ARCHITECTURAL REVIEW COMMITTEE MEMORANDUM

DATE: AUGUST 30, 2021

SUBJECT: STARBUCKS FOR A SIGN PROGRAM AMENDMENT TO THE SUNRISE SQUARE SHOPPING CENTER ESTABLISHING SIGN CRITERIA FOR THE COFFEE SHOP BUILDING LOCATED AT 1755 NORTH SUNRISE WAY, CDN ZONE. (CASE SP 21-003) (GM)

2 SOUTH ELEVATION - REAR (FACES ADJACENT BANK BUILDING & E VISTA CHINO) Scale: 1/8" = 1'-0"

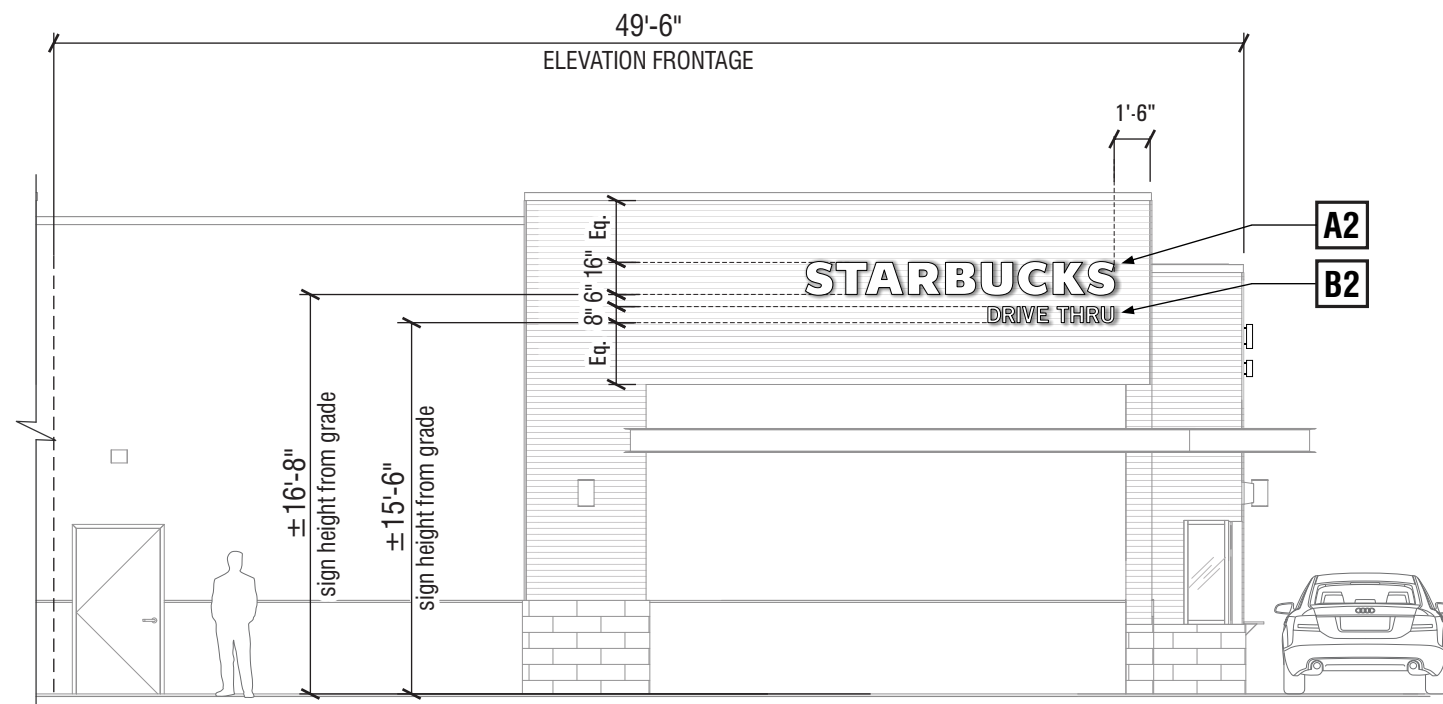
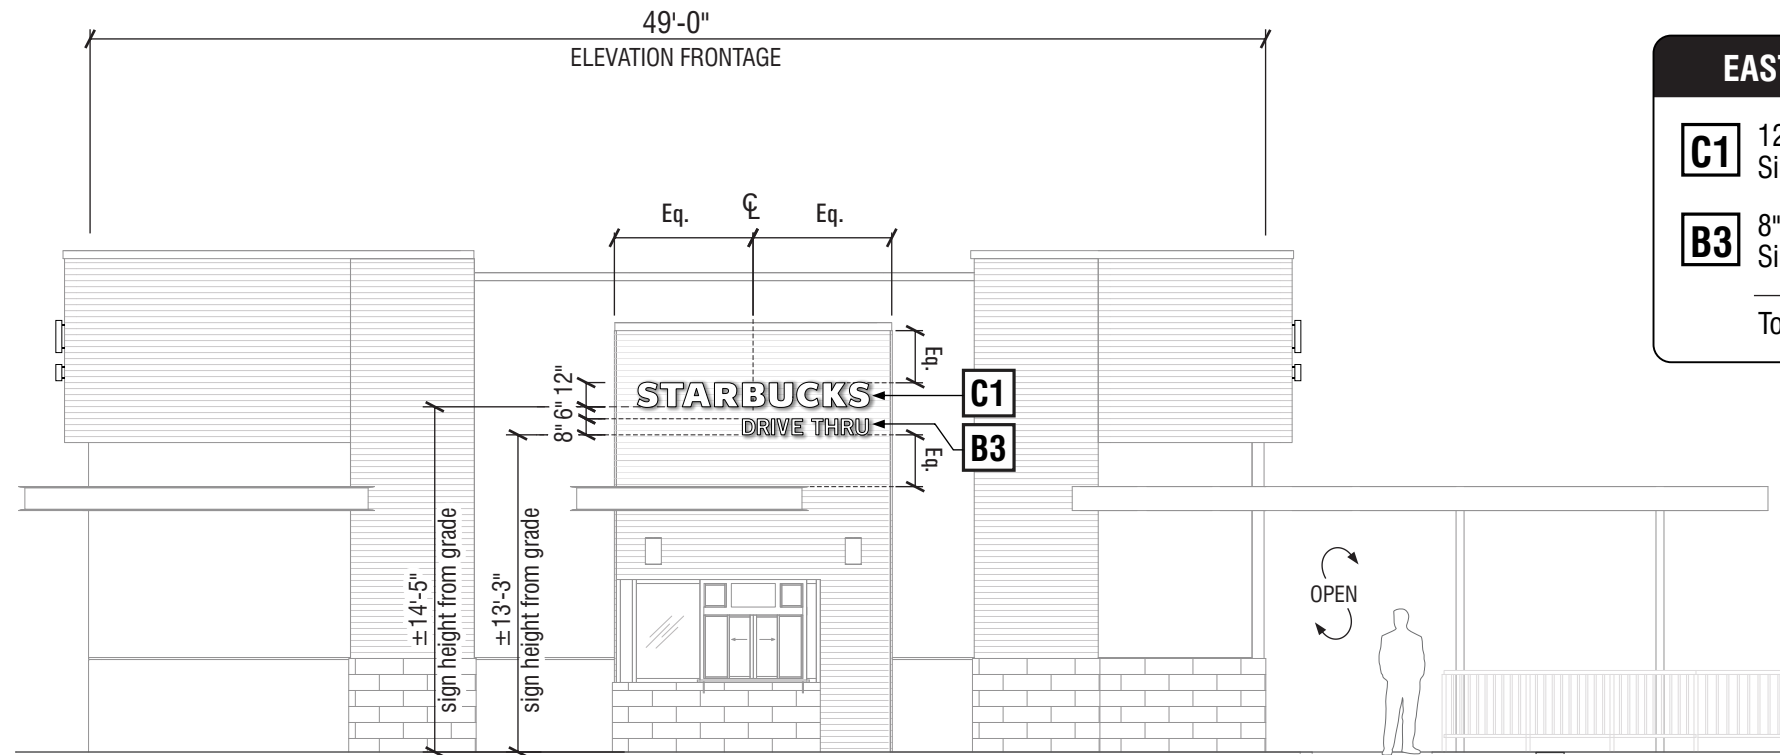
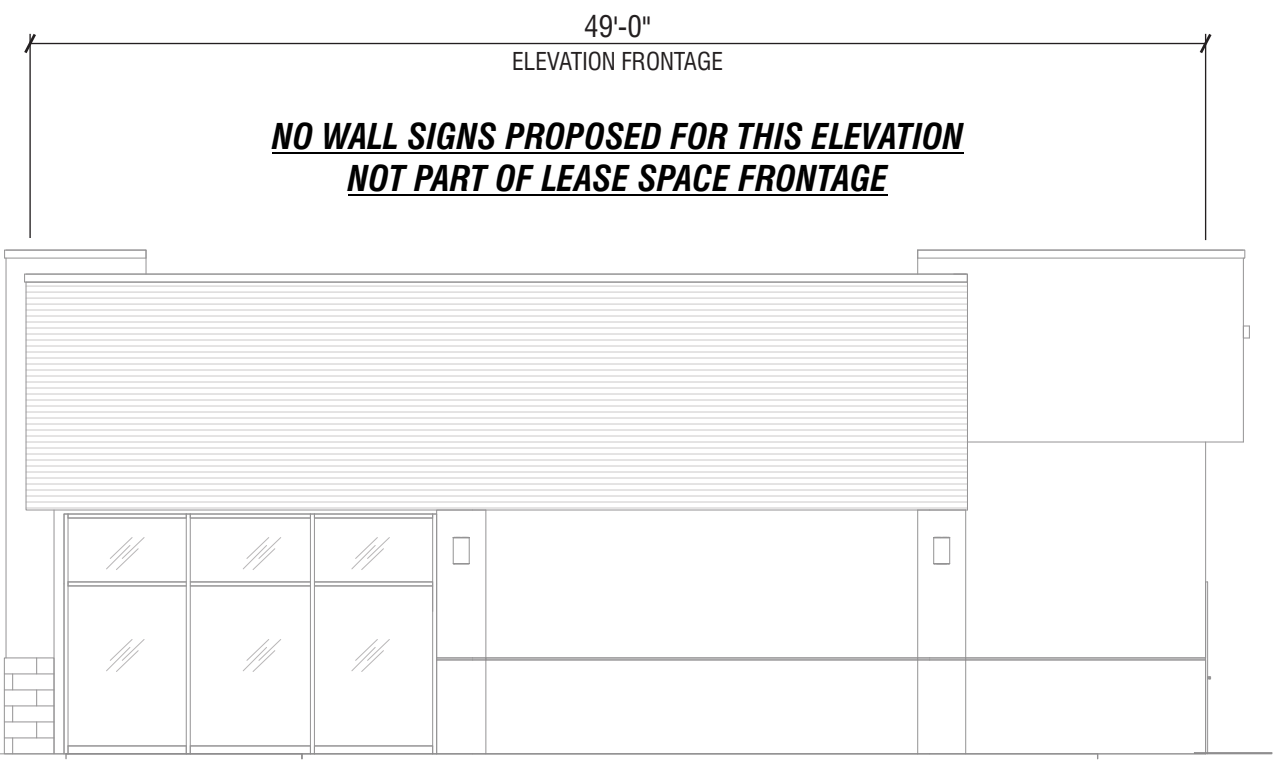
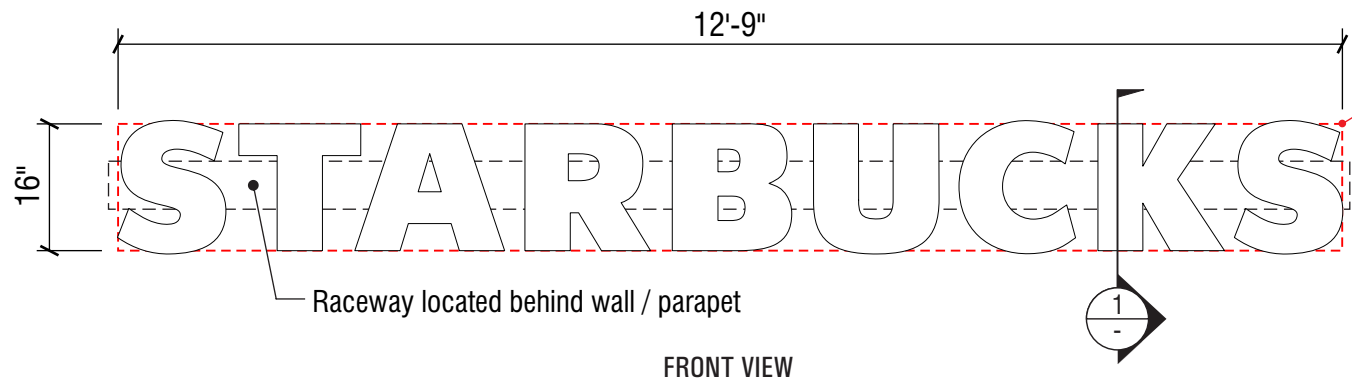
- 1) Future sign locations for Tenant "B" be illustrated on a building elevation to be consistent in size and placement.
- 2) Give direction on the appropriateness of the new monument sign; size, location, and design.

The developer of the building has stated that the second tenant has not been determined and until that decision has been made it would be premature to provide signage. Staff disagrees and has asked that exhibits show the possible location of the signs on the building which helps illustrate the relationship of the two tenants.

NEW DOUBLE FACE ILLUMINATED TENANT MONUMENT SIGN

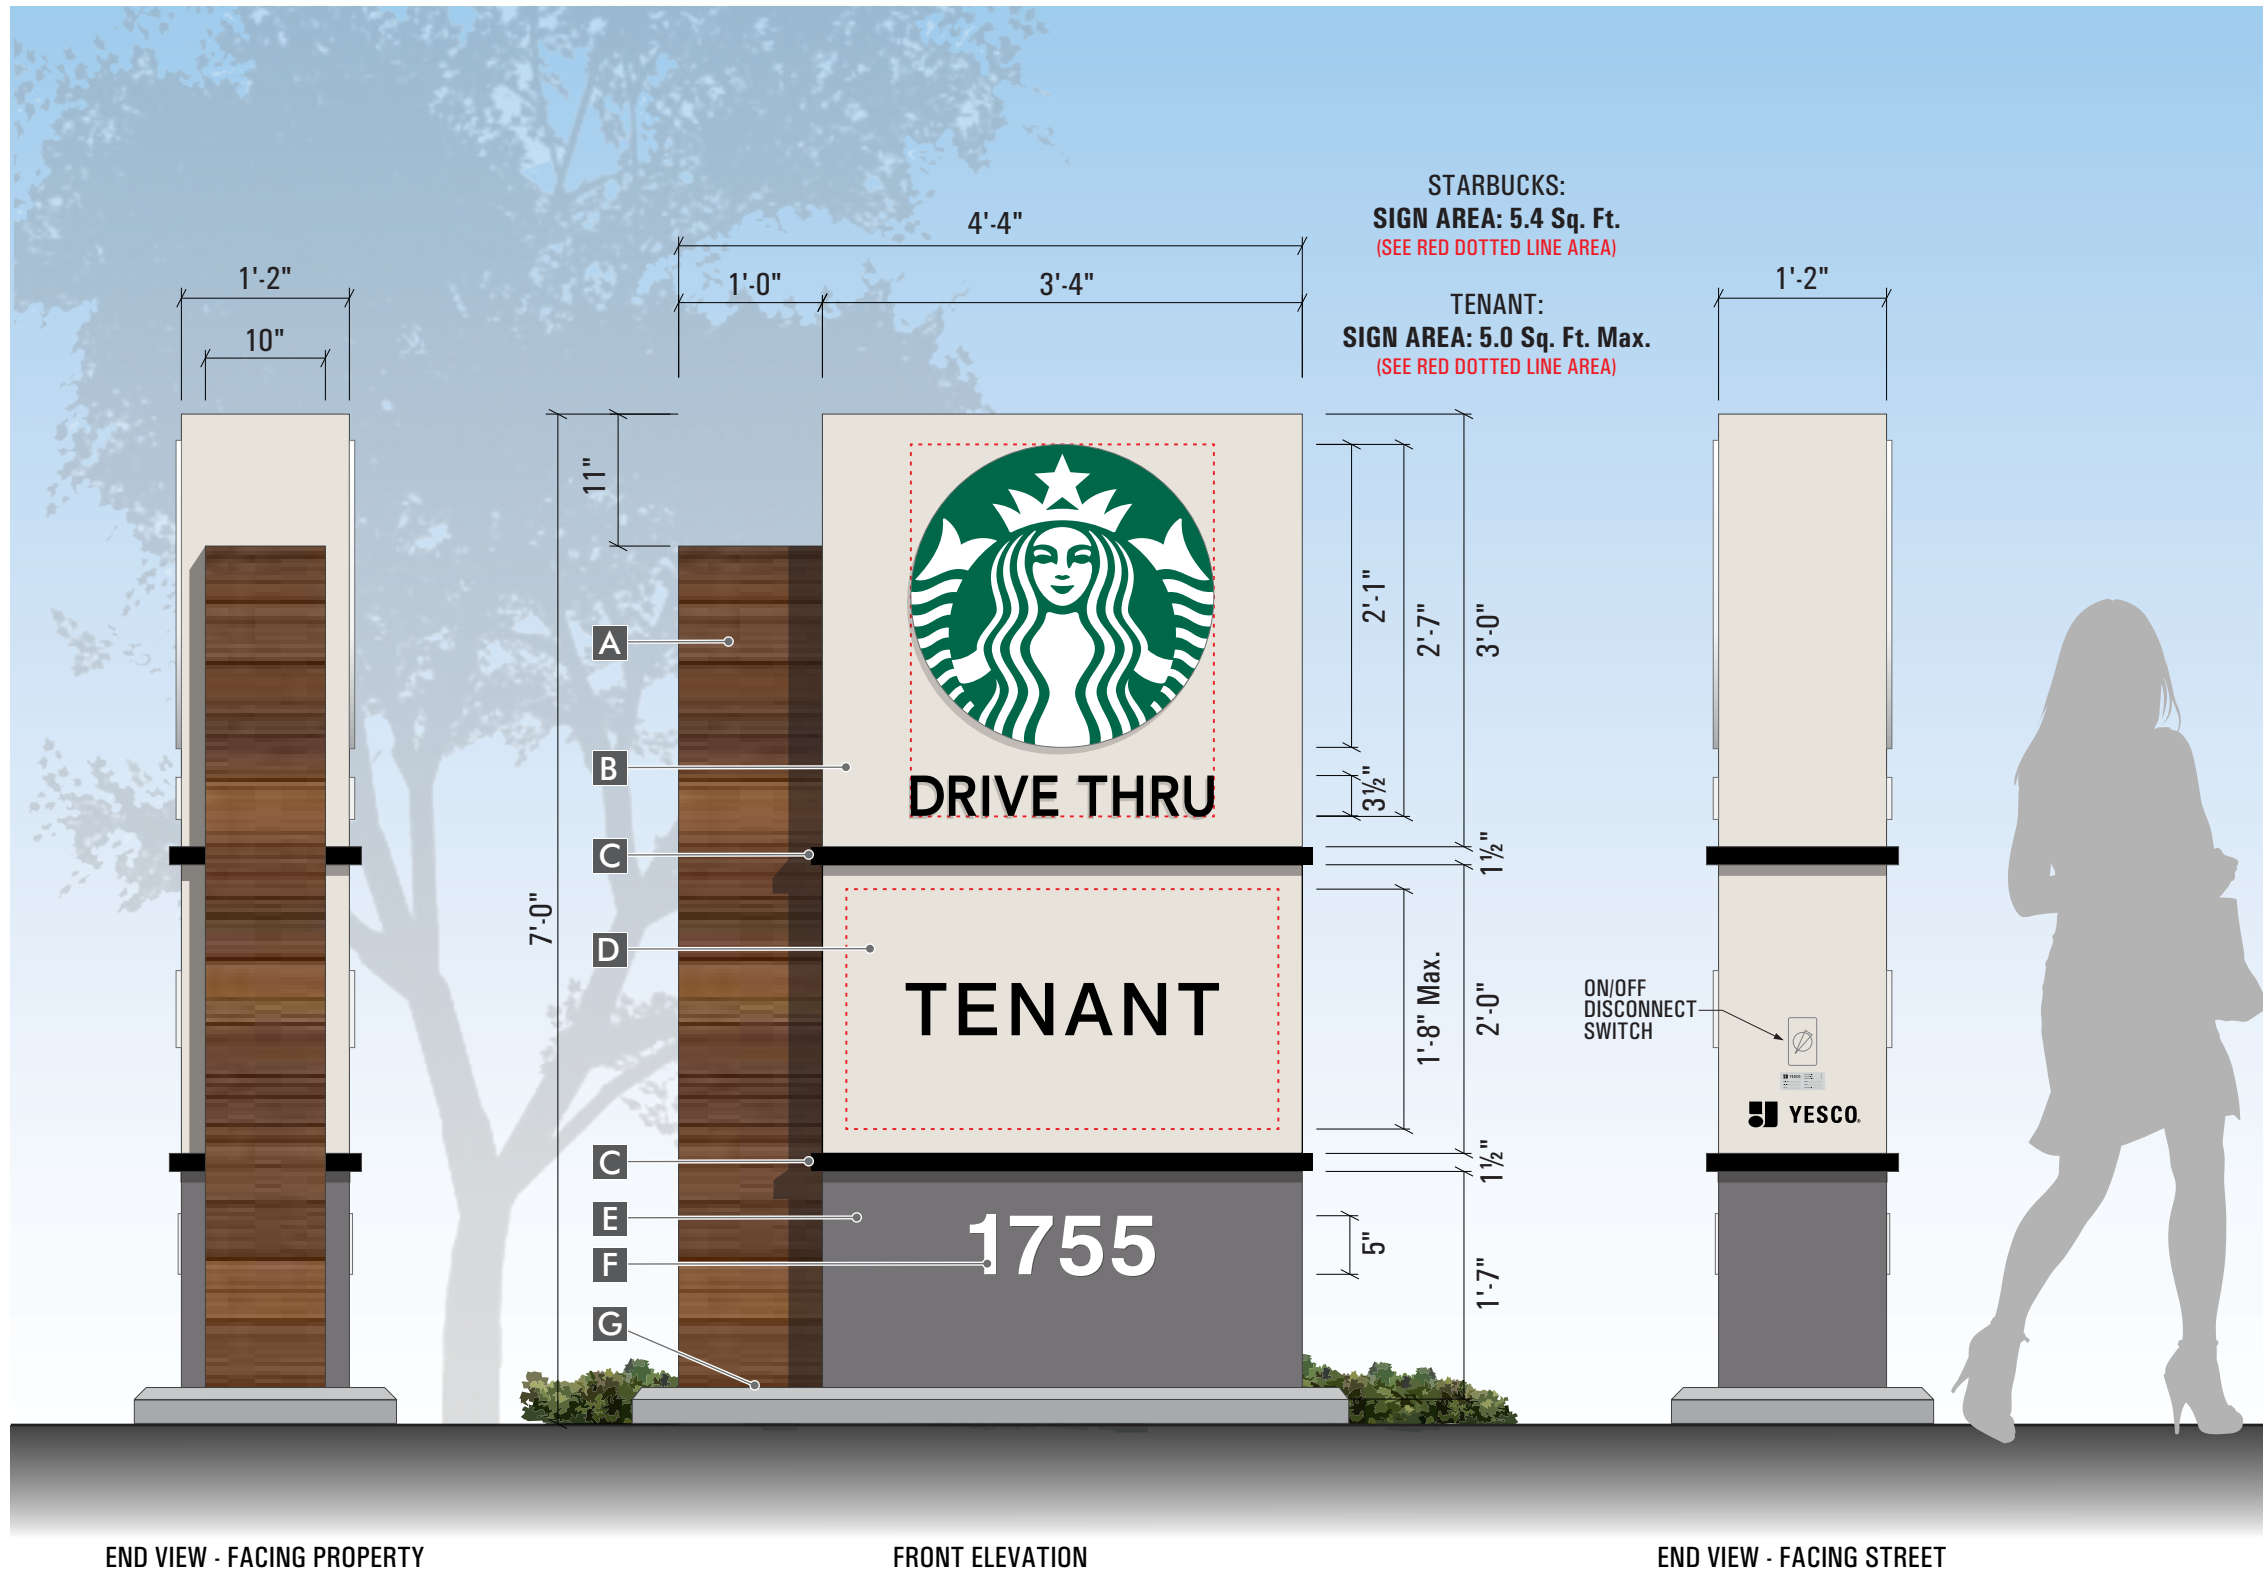
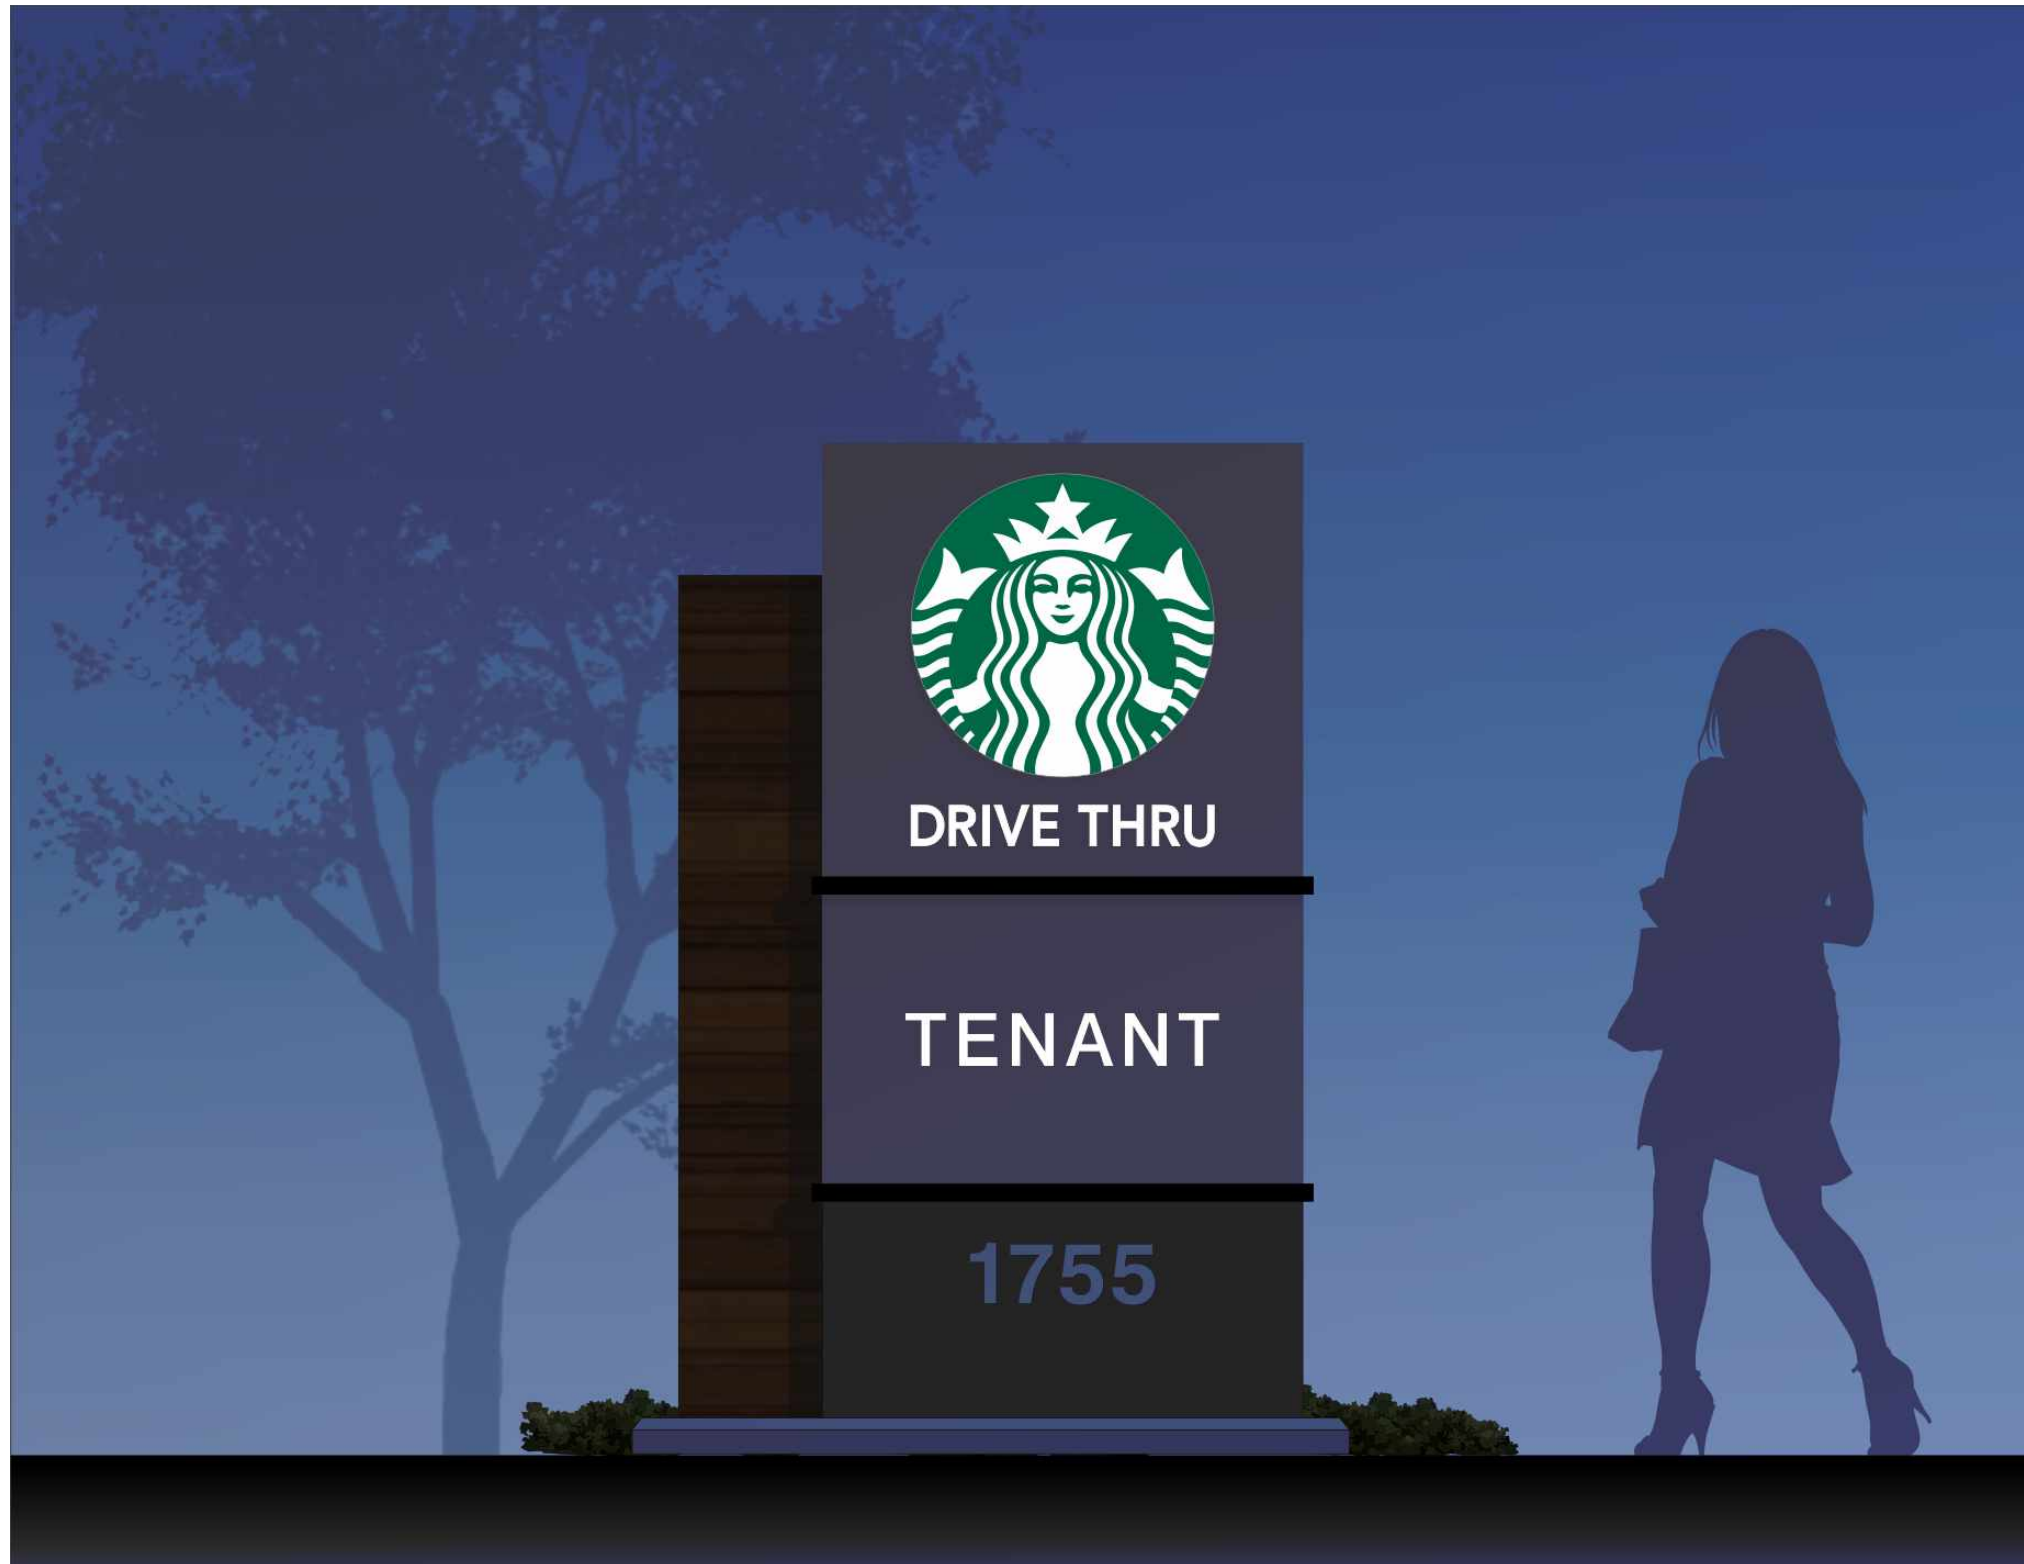
The new monument sign will be seven (7’) feet tall and four (4’-4”) feet wide for a total area of 30.5 - square feet. The sign will be double faced illuminated with two (2) spaces for Starbucks and an unknown tenant. The sign consists of a base constructed of aluminum over a steel frame in a dark grey; the tenant signs are aluminum over steel frame with routed out letters illuminated by LED cabinet lights. A decorative accent column will provide a vertical element with a wood siding finish like the exterior of the new building tying the two together.
